928-940 NW 54TH ST

ADMINISTRATIVE DESIGN REVIEW - 09/02/2021
928-940 NW 54TH ST

MEETING TYPE Administrative Design Review

SOUTHERN FACADE OF THE REAR BUILDING

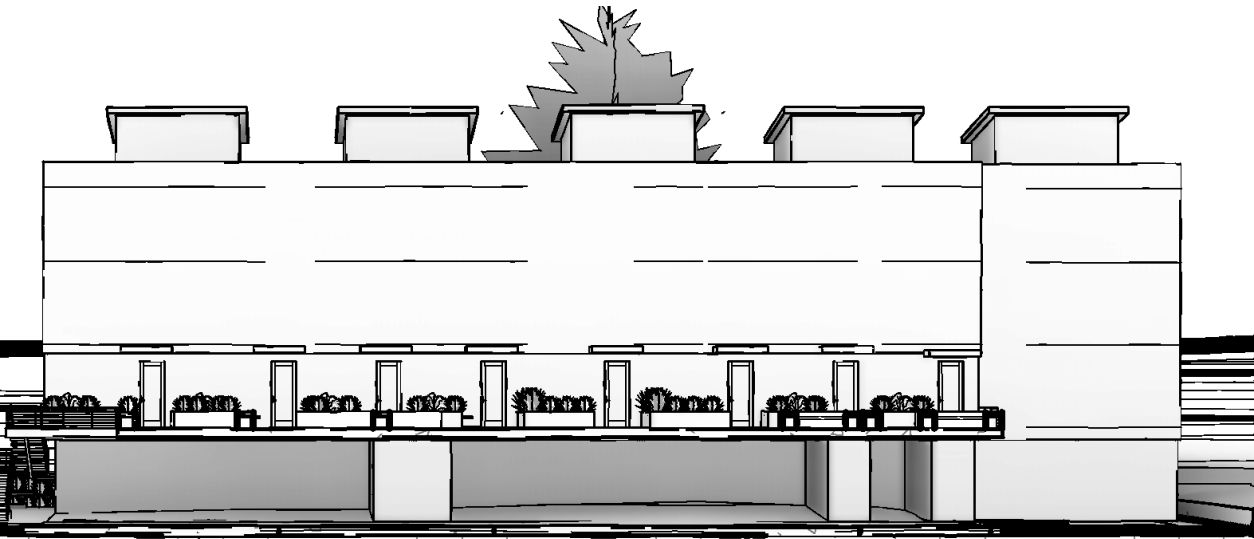
2.f. Based on notes provided on page 32 of the packet, the main entries for the rear townhome units will be on the second level amenity deck. Develop the south-facing facades of the rear townhomes with the same level of modulation, articulation and secondary architectural features that are used on the front elevations of the street-facing townhomes to reinforce the overall architectural concept and cohesiveness of the entire development. CS3-A-1, DC2-B-1, DC2-C, DC2-D-1

Response 2.f: The facades and entry experience of this rear building has been updated to look similar to the street-facing units.

DECORATIVE ENTRANCE GATE EXAMPLES

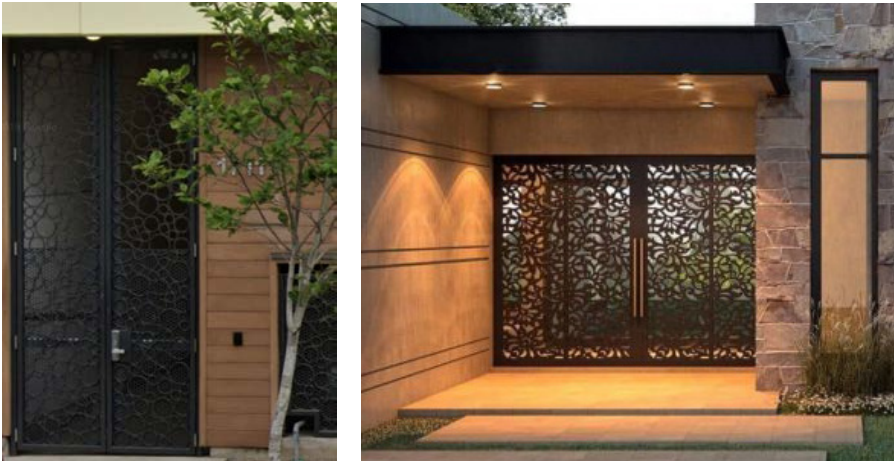
3.b. The entry stair up to the second-floor outdoor deck has the potential to be a dynamic and unique aspect of this development. Staff is concerned about the entry experience because of the narrow building separation and high, unmodulated facades on either side, which create a canyon-like path. Design the shared path to be generous, welcoming, and identifiable. Incorporate secondary architectural features such as decorative lighting, trellises, or other architectural elements to help bring down the scale of the space. PL3-A, DC2-A-1, DC4-C-1

Response 3.b: Materials were wrapped around and brought into the stairway at the first and second levels. As the brick is lighter than the adjacent siding, it will help to break up the massing. Wall sconce lighting will further brighten the space. A decorative gate at the sidewalk will provide visual interest as well as security without an overwhelming sense of utilitarianism. An overhead trellis visually highlights the path, while also lowering the overall bulk of the buildings.

REAR COURTYARD AND SECONDARY ENTRANCES

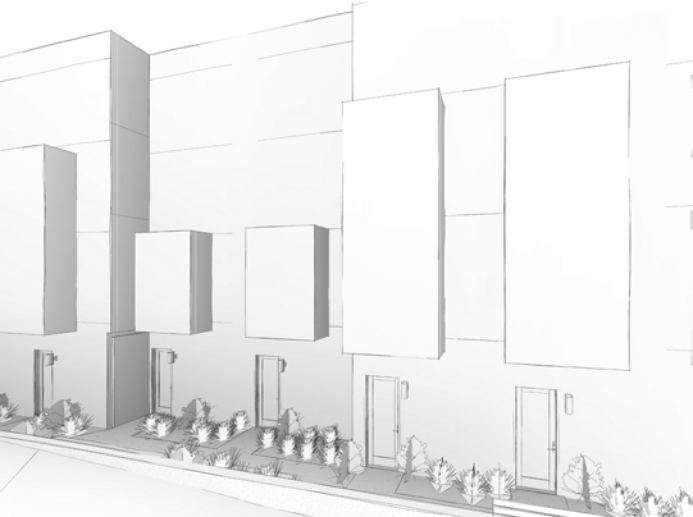
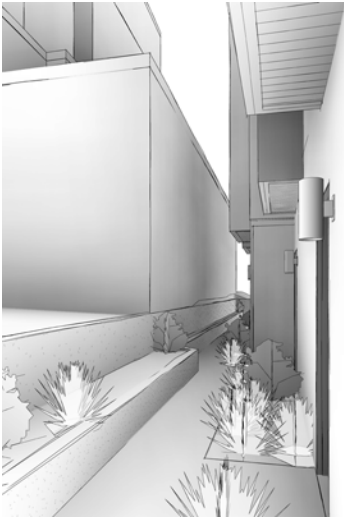
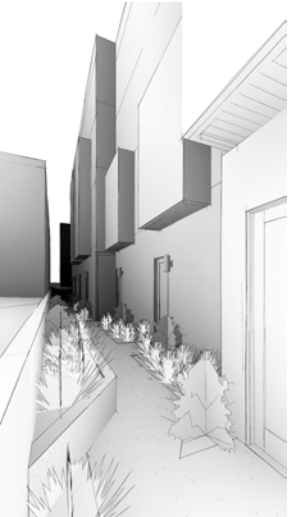
3.d. It is understood that the unit entrances along the north property line are intended to be back doors to the units however, as shown on page 32 of the packet, they lack residential character. Study ways to make this space feel more inviting. One approach could be to break the planter on the north side of the pathway at each unit entry and provide an area for seating. With the addition of decorative lighting such as light bollards or festival lighting in these locations, they would feel less like back doors and would provide welcoming entries for residents. PL3-A-3, PL3-A-4, PL3-B-4, DC2-D-1, DC4-D-1

Response 3.d: Modifications are proposed to include pathway lighting, built-in benches and modulation overhead in the form of furred out walls to give more identity to the individual units.

PARKING GARAGE, LOOKING EAST

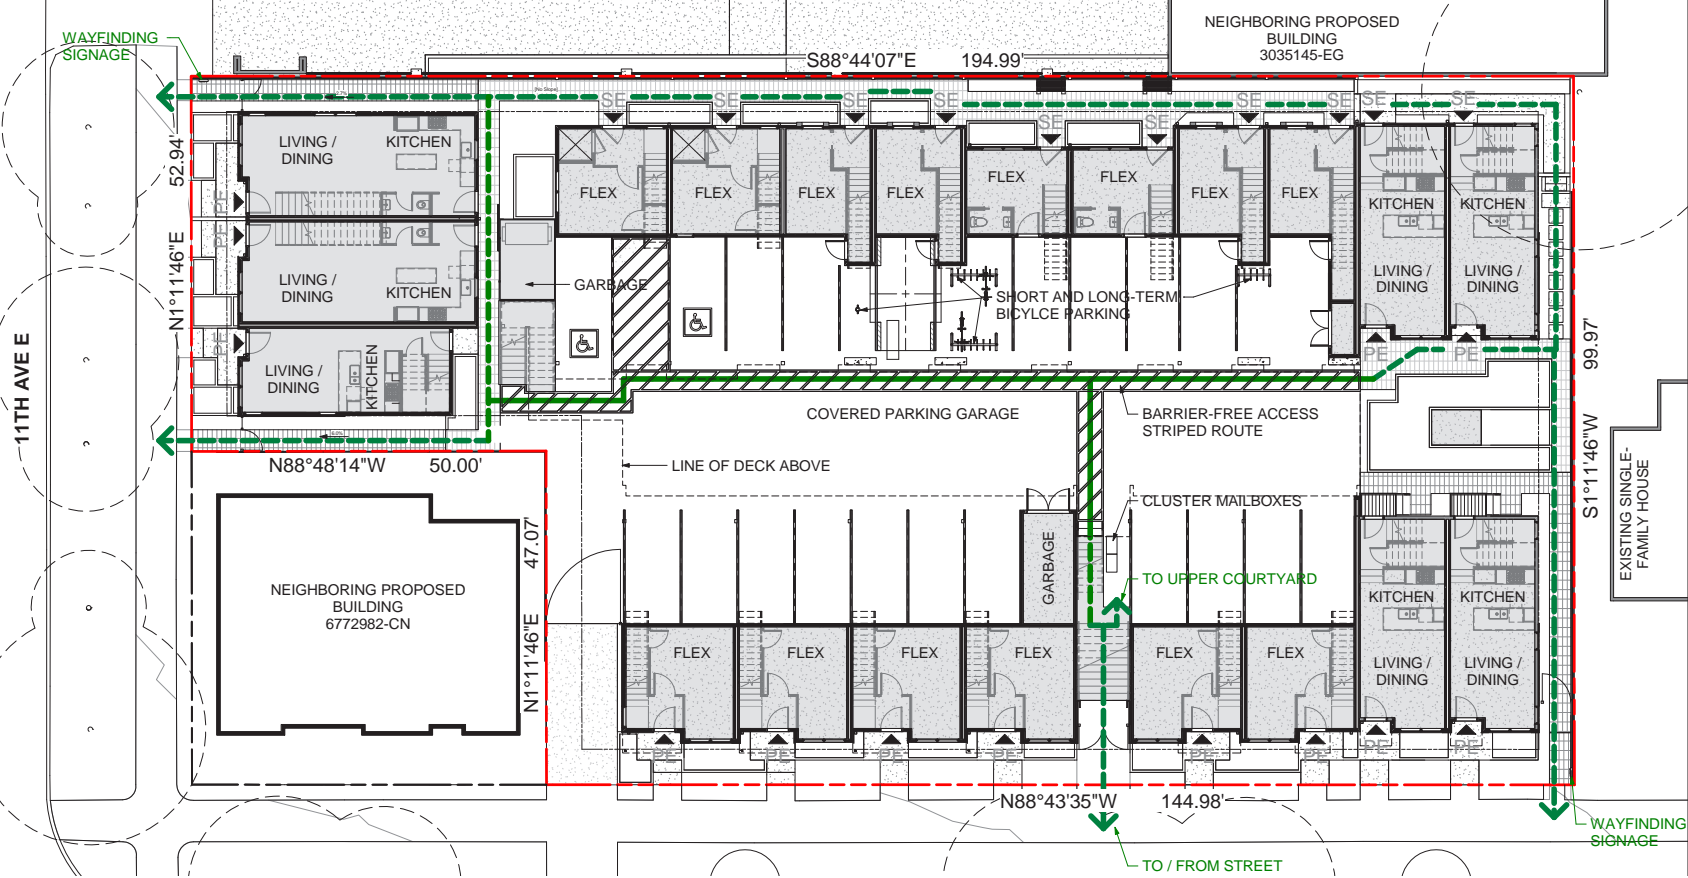
3.g. Staff applauds the applicant for covering the parking with a usable outdoor space. The applicant should take care in designing the parking court to be bright, inviting and well-lit both during the day and at night. Clarify how residents circulate out of the parking court. PL2-B-2, PL3-B-1

Response 3.g: The parking garage is open from two ends, allowing daylight to stream through, but will still be lit by use of exterior ceiling lighting for an additional light source. The same siding materials will be brought down into the garage to feel more residential in nature, as opposed to utilitarian garage. The color scheme will be lighter, to be more reflective of the light.

Pathways will be marked on the ground to indicate safe pathways in, through and out of the garage.

BICYCLE STORAGE

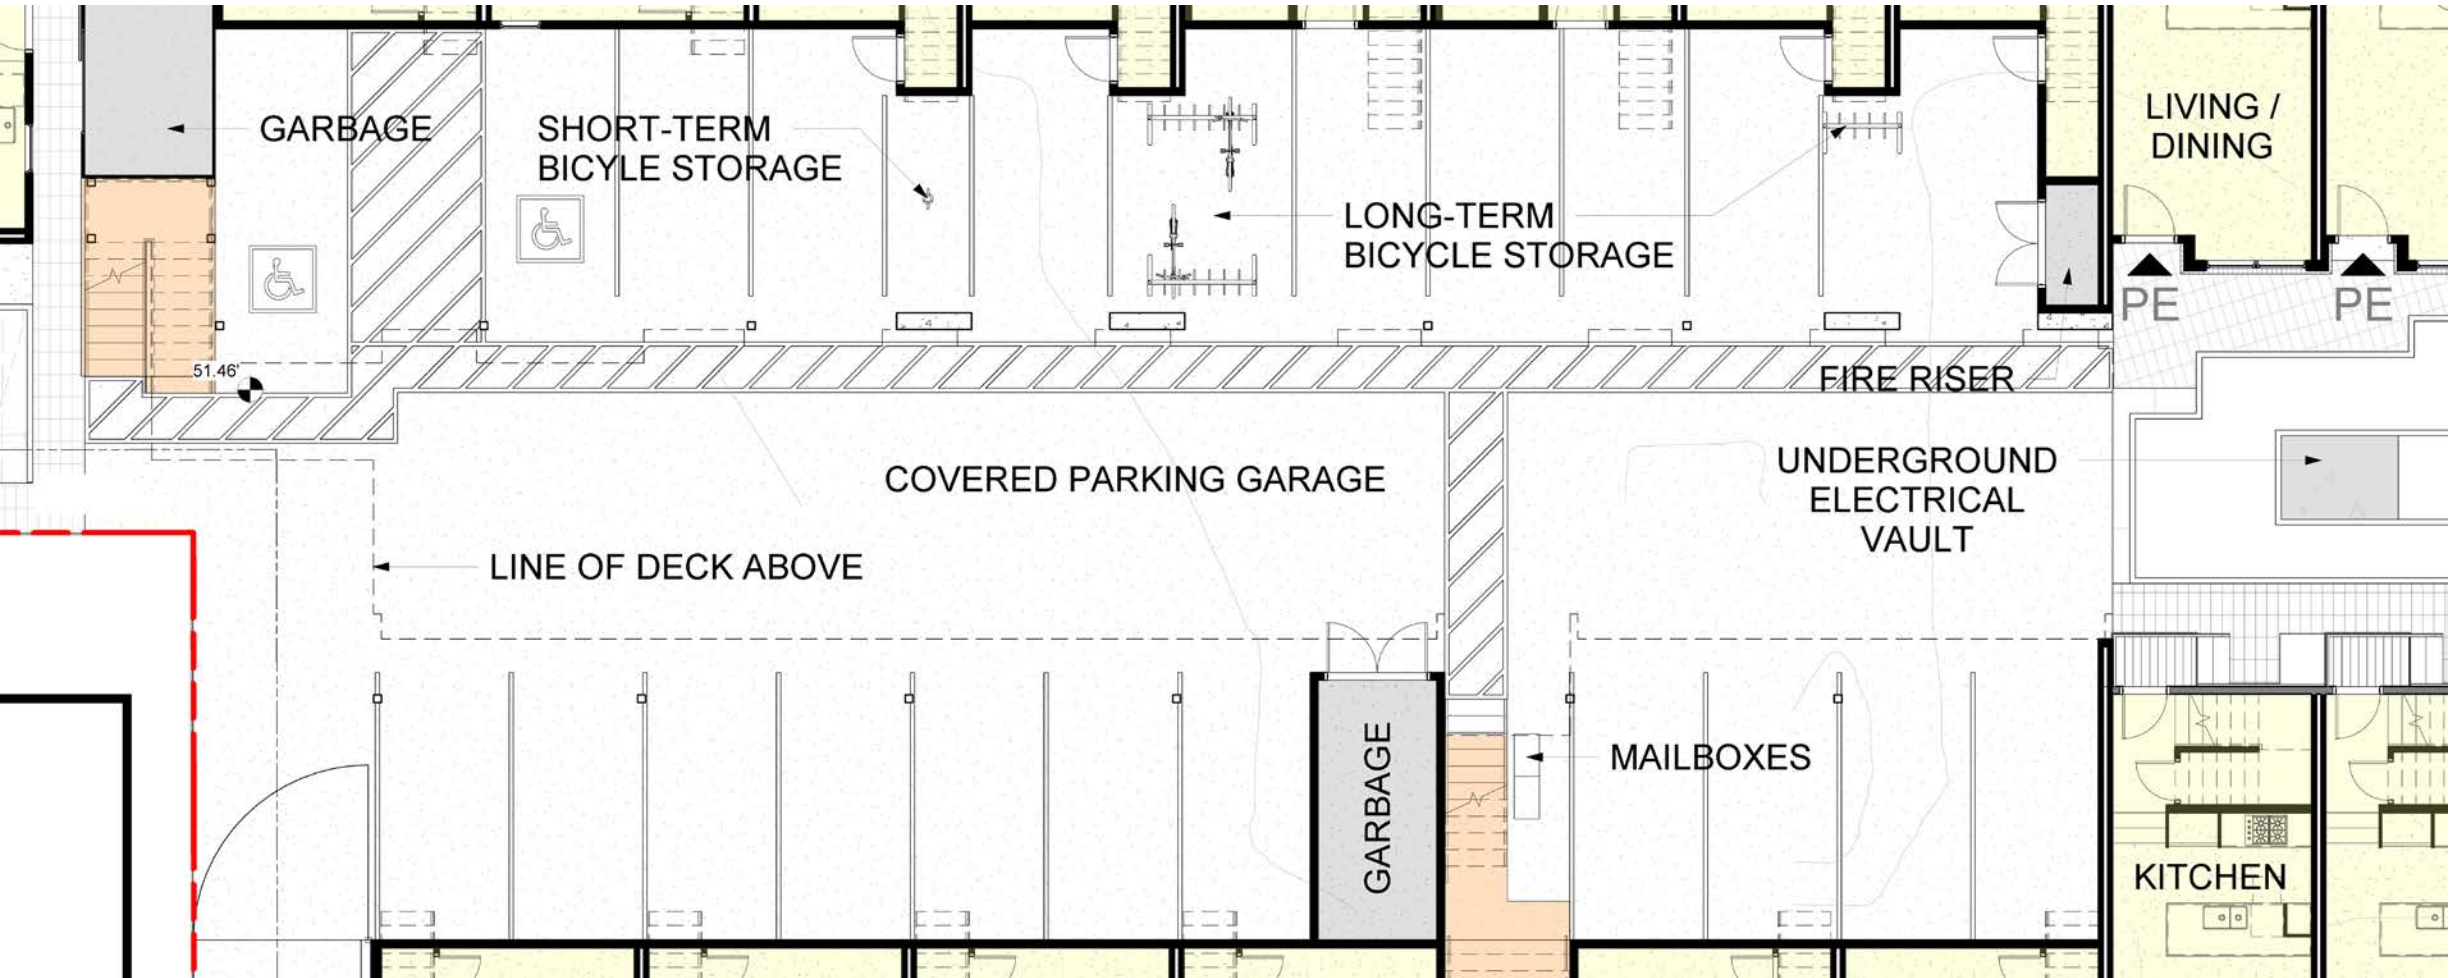
3.i. Include information on where bikes will be stored. PLA-B-2

Response 3.i: Bicycle storage locations can be found in multiple locations throughout the covered garage.

CIRCULATION PATHWAYS

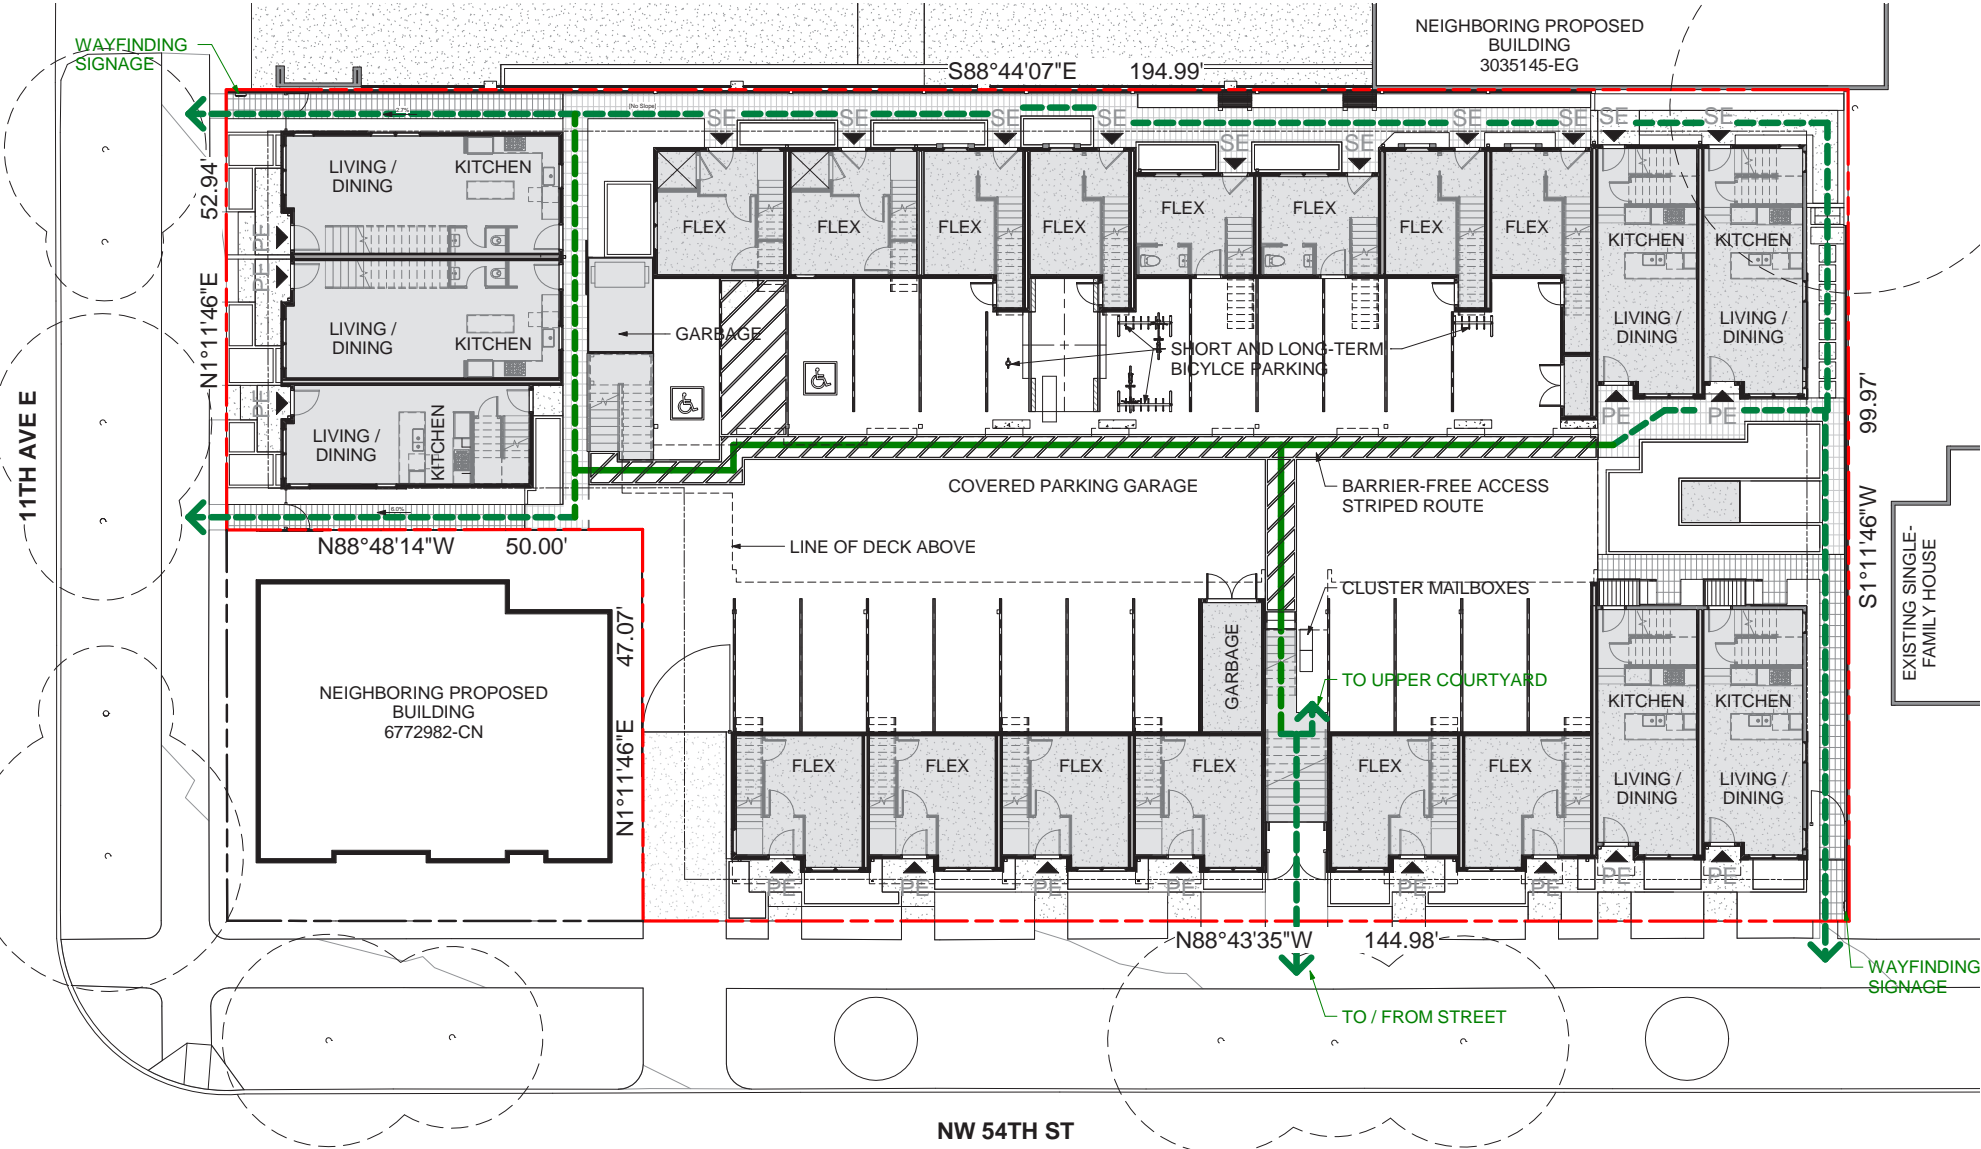
4.d. Continue to develop the hardscape design of the parking court. Use changes in paving type, color, and texture to help with wayfinding and delineating pedestrian paths. PL2-D-1, DC4-D-2

Response 4.d: Painted striping will be utilized to delineate pedestrian walkways.

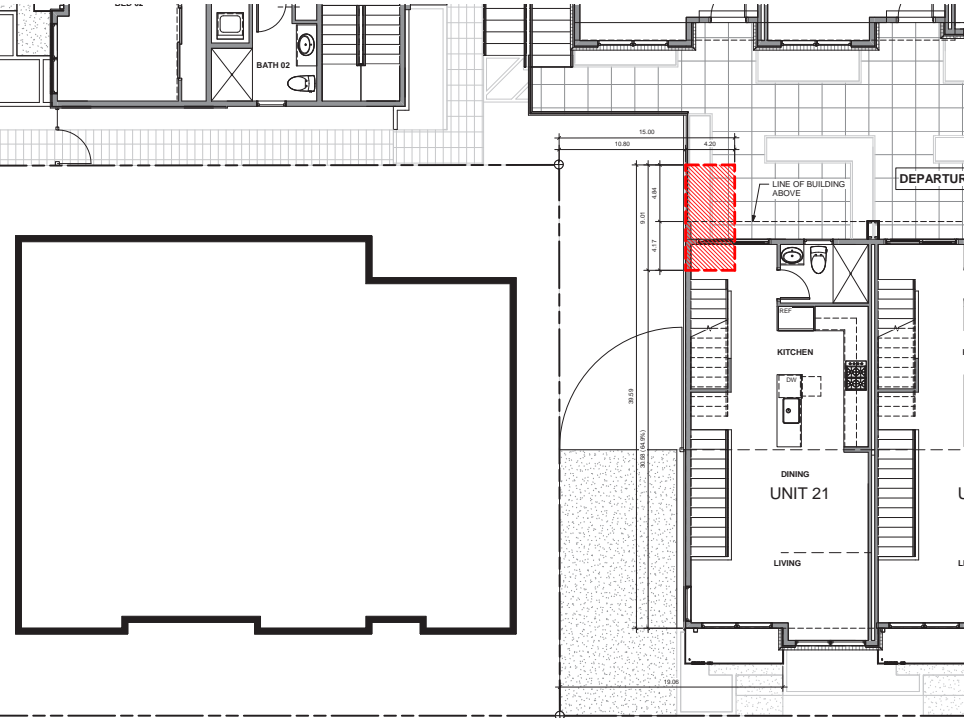
1. Structure width and façade length limits in LR zones (SMC 23.45.527.B.1):
The Code states that the maximum combined length of all portions of facades within 15 feet of a lot line that is neither a rear lot line nor a street or alley lot line shall not exceed 65 percent of the length of that lot line. The applicant proposes a portion of wall that is longer than the maximum allowed length by 4 feet 2 inches. Facades within 15’ of this west lot line would be 84% of the length of that lot line.

The additional façade length requested for Architectural Massing Option 3 will have little impact on the perceived height, bulk, and scale from NW 54th St and 11th NW. The corner property to the west, that shares the same property line, is being developed by the same ownership group. The design of that townhome development is the same as the design for this proposal and shares the same modulation and articulation. The design with this departure meets the intent of Design Guideline CS2-D Height, Bulk and Scale and is preliminarily supported by Staff.

Staff Note: If all recommendations and guidance in this report are resolved, this departure for Architectural Massing Option 3 will not be required. Also note that Staff does not support the development of Architectural Massing Option 1 or departures related to that option, or Architectural Massing Option 2, as shown in the EDG packet.

Response: *The departure request is included in the packet, as the departure is still being requested due to the aforementioned reasons of loss of parking opportunities. The departure allows the design to provide 2 parking stalls under the unit in question. The loss of the ground floor space in this unit translates to longer upper stories to preserve appropriate unit sizes and internal function.*
